SEWAGE DISPOSAL SYSTEM
HOWARD COUNTY HEALTH DEPARTMENT
BUREAU OF ENVIRONMENTAL HEALTH
410-313-2640

A REPAIR

SUBDIVISION Countryside LOT NUMBER 9 ADDRESS 3559 Countryside Drive

REPAIR - PURPOSE - Existing septic system has failed.

Well HO-73-4162
NOT TO SCALE

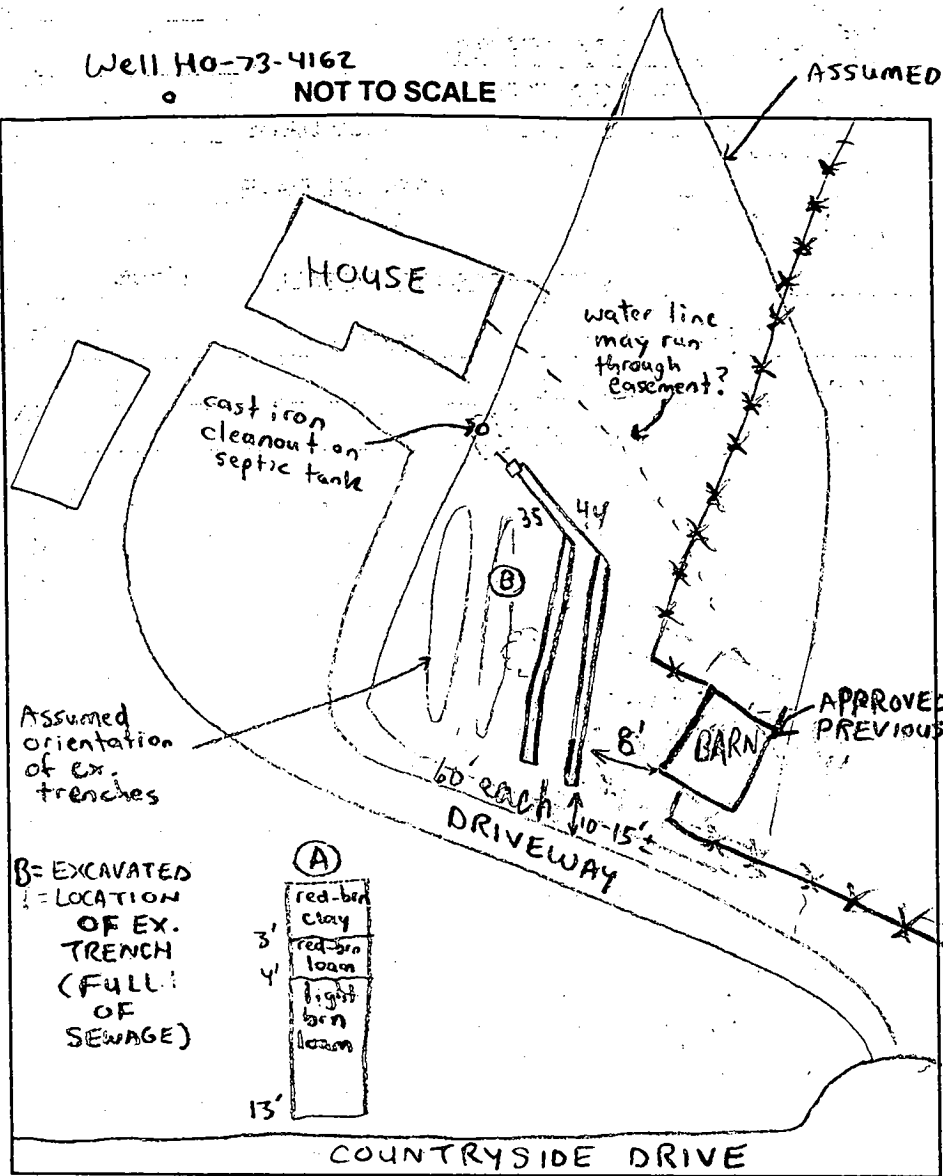
Run 2 (54') TRENCHES TOWARDS THE DRIVEWAY

KEEP TRENCHES 7' EDGE TO EDGE

PRE-CONSTRUCTION INSPECTION: 1/3/01 - INSTALL TRENCHES AS SPECIFIED ON FRONT OF PERMIT HOLE DUG IN LOCATION (B) & (A), SEE SOIL PROFILE, OK TO COVER MIDDLE OF TRENCHES BUT KEEP ENDS OPEN, POLE BARN (APPROVED PREVIOUSLY) IMPACTS PORTION OF SEPTIC EASEMENT, ADVISED HOME OWNER FUTURE REPAIRS MAY INVOLVE THE REROUTING OF WATER LINE AROUND EASEMENT IF INSPECTION COMMENTS: APPLICABLE PIPE FROM SEPTIC TANK TO EX. DBOX REPLACED W/ PVC PRIOR TO 1/3/01 BY CONTRACTOR, OK TO BEGIN WORK - (SRM)

1/4/01 OK TO FINISH & COVER (MR)
